THE MARYLAND-NATIONAL CAPITAL PARK AND PLANNING COMMISSION

MEMORANDUM

REVIEW TYPE: Site Plan Review
CASE #: 8-03041
PROJECT NAME: Maple Ridge Townhomes
APPLYING FOR: Approval of 59 townhouses including 8 MPDUs

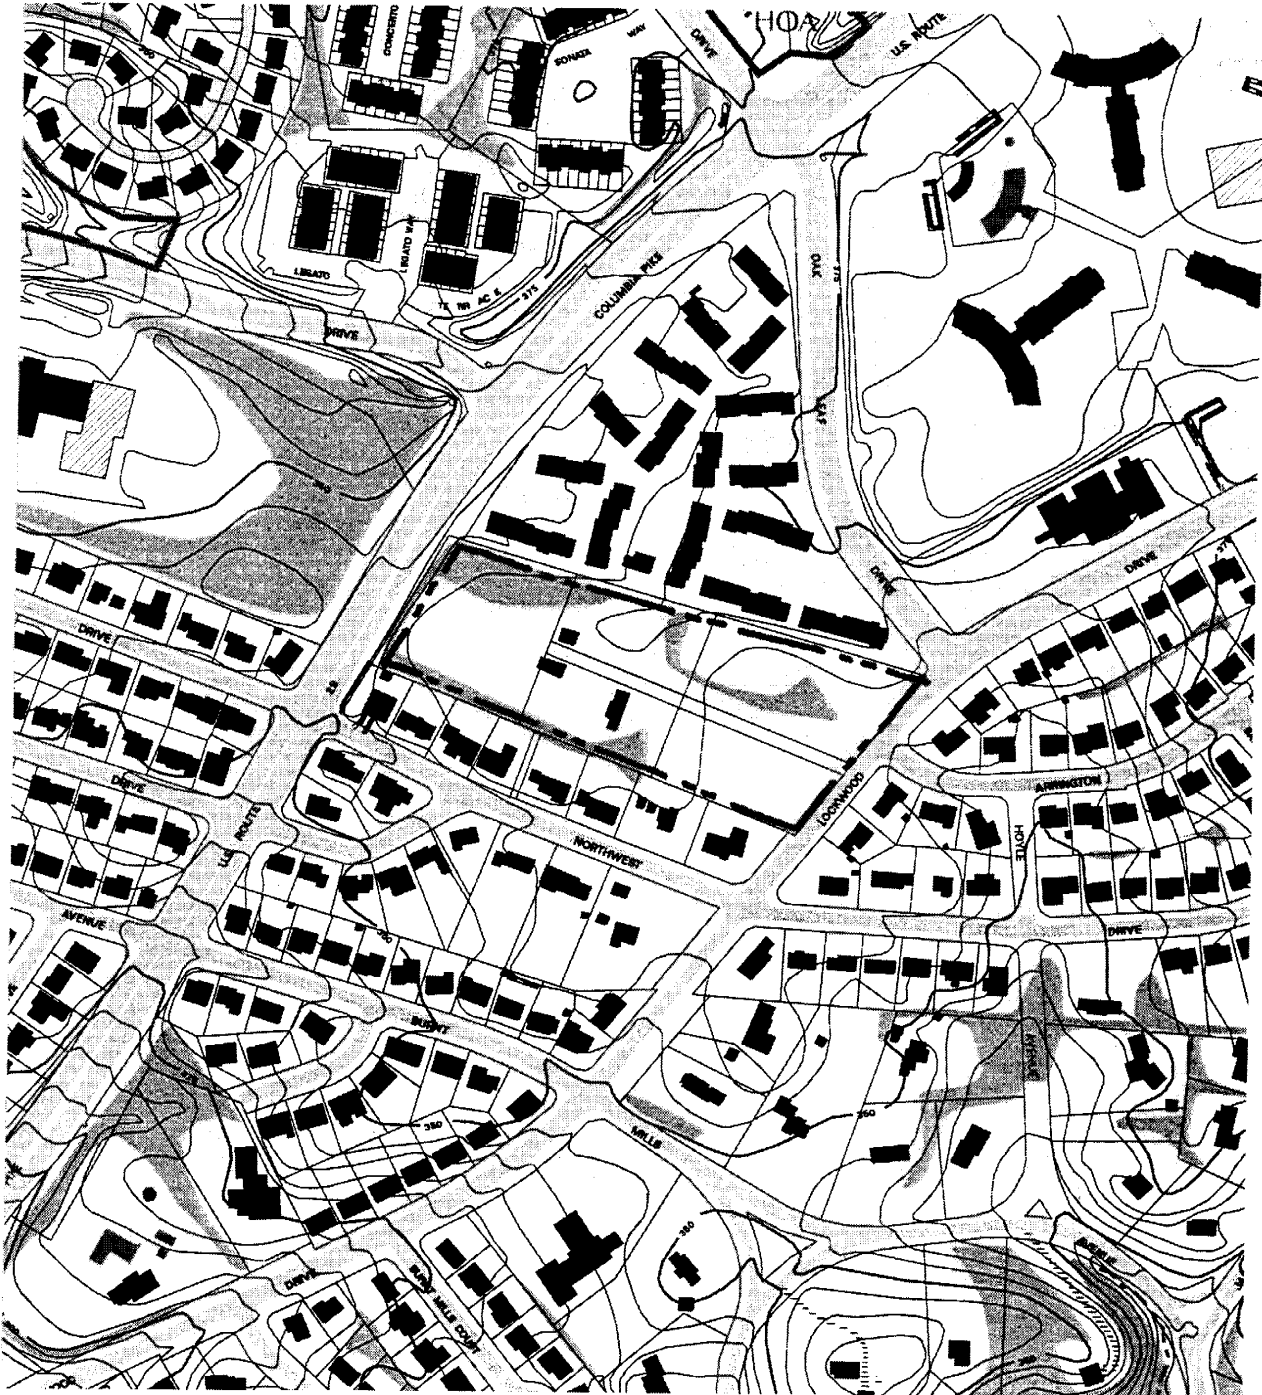
Local citizens request Class I bikeway instead of Class II along this section of Lockwood Drive to provide a safe bike path for the users.

- Class I - Staff recommends change from a Class II bikeway to a Class I bikeway in response to local citizen requests as well as a result of field work conducted by staff as part of the planning process for the Master Plan of Countywide Bikeways (MPCB). This change is consistent with the 1997 Approved and Adopted White Oak Master Plan, which recommended either a Class I or Class II bikeway along the section of Lockwood Drive between US 29 and White Oak Commercial Center.

- Class III- In addition to the Class I facility now being proposed for Lockwood Drive, in response to comments from the bicycling community during the MPCB planning process, staff is recommending a Class III on-road bikeway facility for Lockwood Drive to provide both on-road and off-road accommodation for bicyclists along the Lockwood Drive corridor. The Class I facility provides an important local bikeway connection to the White Oak Shopping Center, while the Class III provides a critical link in the regional US 29 commuter bikeway. Though not recommended in the 1997 White Oak Master Plan, the above Class III bikeway facility is being proposed for Lockwood Drive in the MPCB. A staff draft of this plan will be presented to the Planning Board on October 23, 2003.

The applicant agrees to provide an eight-foot-wide Class I bikeway along the Lockwood Drive frontage and to extend the bikeway to Northwest Drive to the south and to Oak Leaf Drive to the north. The applicant also agrees per staff request to provide a 22-foot-wide paved area from the centerline of Lockwood Drive along the entire property frontage for future on-street parking and a travel lane compatible with an on-road, shared use Class III bikeway.
